Access Compliance Report

Public Rights-of-Way

(Curb Ramps)

Intersection ID: 6318	Main Street: FRANKLIN_THOMAS_PL	Cross Street: JORDANS_POND_LN	Location:	N/A
ADA ID: 76D4203F675F	Ramp Type: Perp	Initial Pass/Fail: Fail	Overall Compliance: No	Severity Score: 10
Codes/Mitigation Info/Possible Solution		Field Measurements/Component Compliance

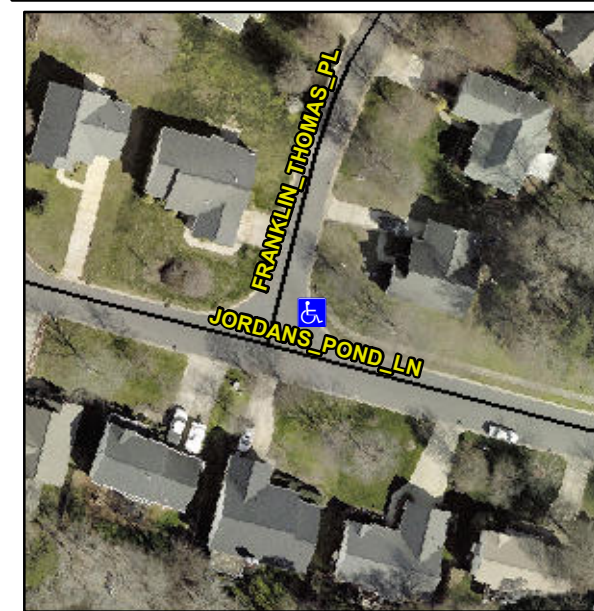
Not Found, R304.5.1, R304.5.3

Compliance	Description	Data	Compliance	Description	Data
N/A	Ramp Length (in)	46.0	Yes	Ramp Slope (%)	5.8
No	Ramp Width (in)	47.0	No	Ramp XSlope (%)	2.7
N/A	Flare Type LT	N/A	N/A	Flare Type RT	N/A
N/A	Flare Slope LT (%)	N/A	N/A	Flare Slope RT (%)	N/A
N/A	Flare Traversable LT?	N/A	N/A	Flare Traversable RT?	N/A
N/A	Landing Length (in)	N/A	N/A	DWS Provided?	N/A
N/A	Landing Width (in)	N/A	N/A	DWS Contrast?	N/A
N/A	Landing Slope (%)	N/A	N/A	DWS Length (in)	N/A
N/A	Landing X Slope (%)	N/A	N/A	DWS Full Width?	N/A
N/A	Landing Curb? (Y/N)	N/A	N/A	DWS Offset (in)	N/A
N/A	Shared Landing?	N/A			
N/A	Gutter Ponding?	N/A	N/A	Gutter Slope (%)	N/A
N/A	Gutter Lip Ht (in)	N/A	N/A	Gutter X Slope (%)	N/A
N/A	Painted X Walk1?	No	N/A	Painted X Walk2?	N/A
	X Walk 1 Direction	To W		X Walk 2 Direction	N/A
N/A	X Walk 1 Width (in)	N/A	N/A	X Walk 2 Width (in)	N/A
	X Walk 1 Slope (%)	0.7		X Walk 2 Slope (%)	N/A
	X Walk 1 X Slope (%)	0.1		X Walk 2 X Slope (%)	N/A

Remove & Replace Entire Ramp.
